Document ID: IK1200131
Revision: 4
Created: 9/4/2007
Last Modified: 2/12/2014
Author: Robert Beckett

Title: Turbocharger to CAC hose coming off on MaxxForce™ 7 Engines - CAC Hose Clamp Alignment and Torque Update

Applies To: All Models with 2007 MaxxForce 7 (V8) Engines

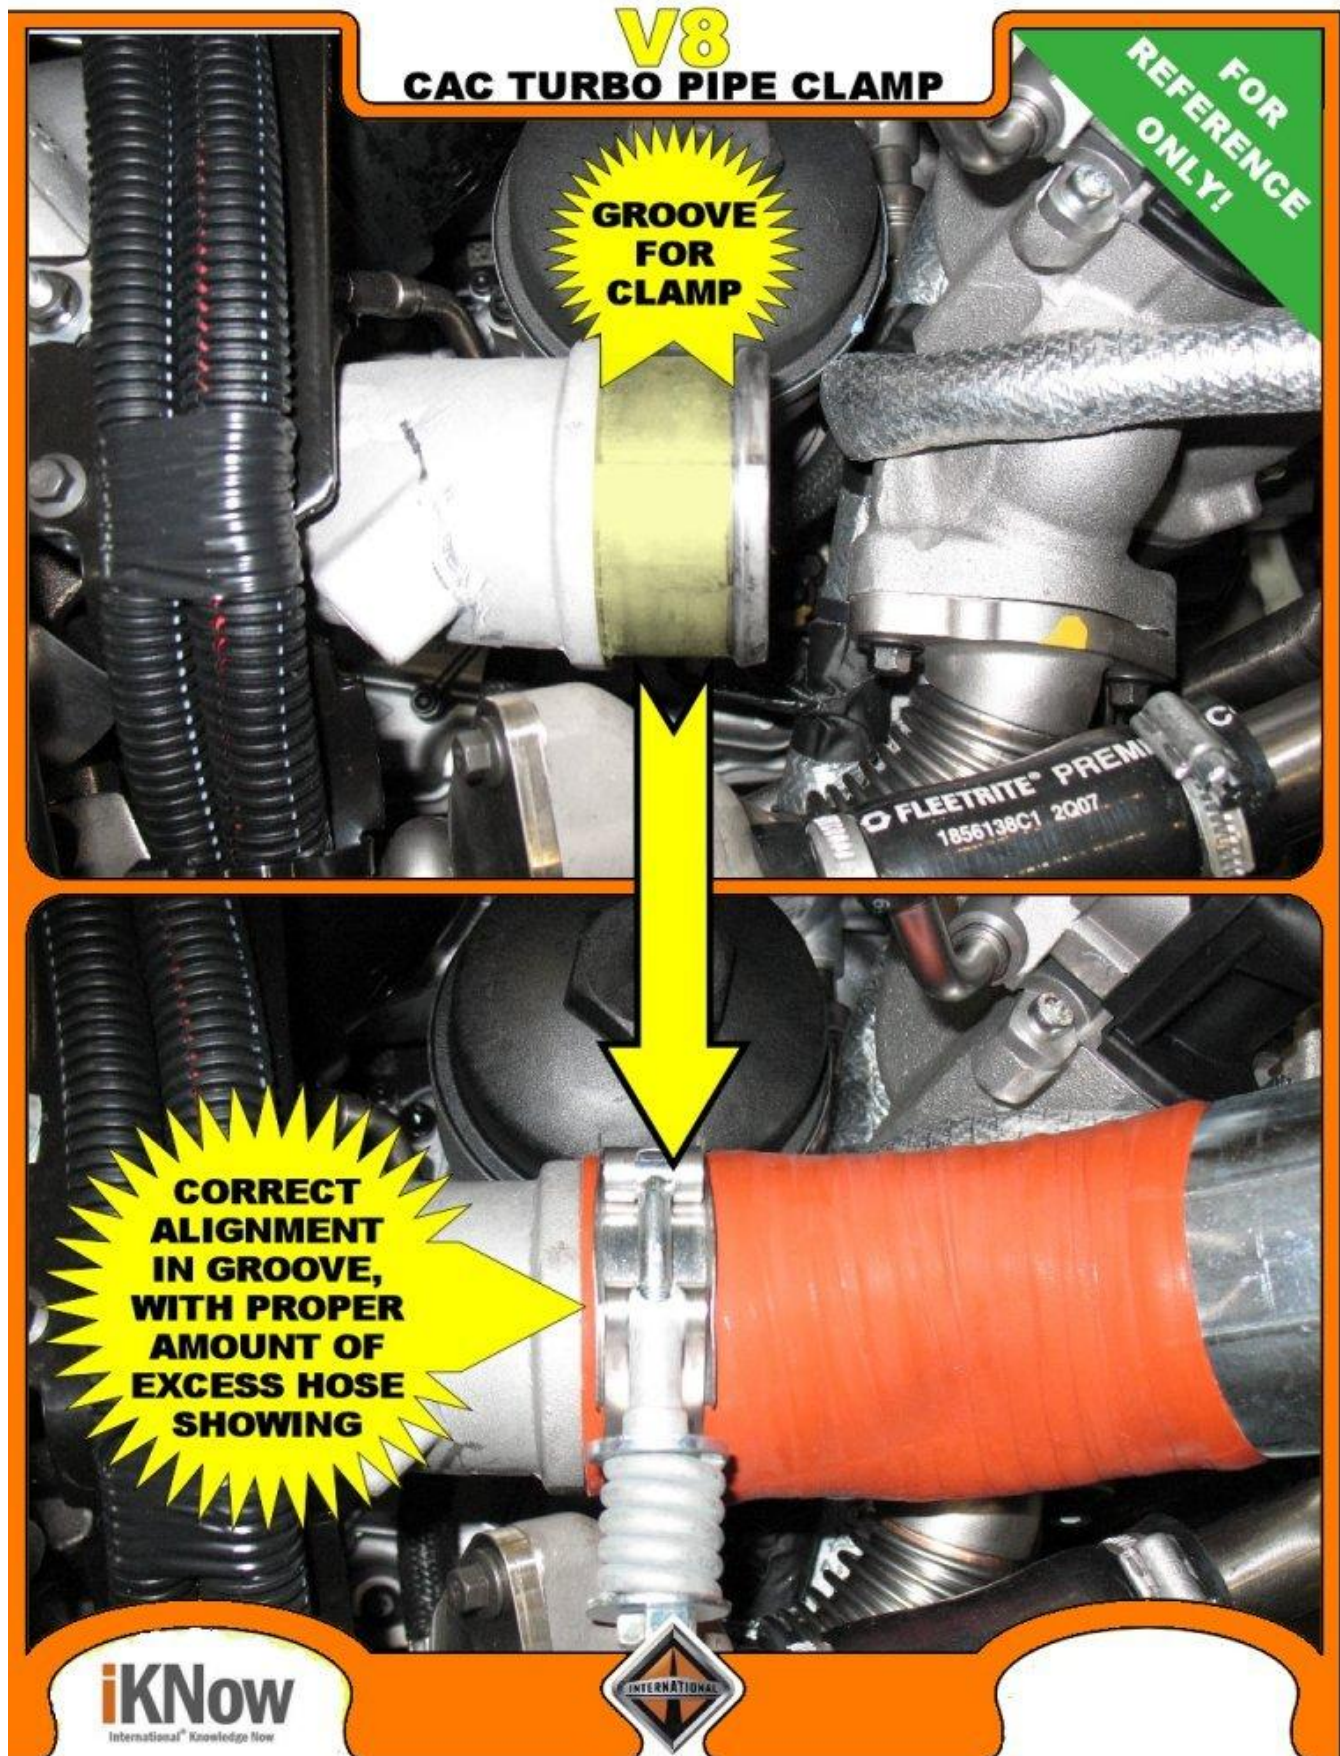
Trbocharger to CAC hose coming (blowing) off on certain MaxxForce™ 7 Engines

Updated clamp alignment and torque.

The clamp should be aligned in the center of the housing groove as shown in the photo below.

The torque for this clamp has been increased to 95 - 100 inch pounds
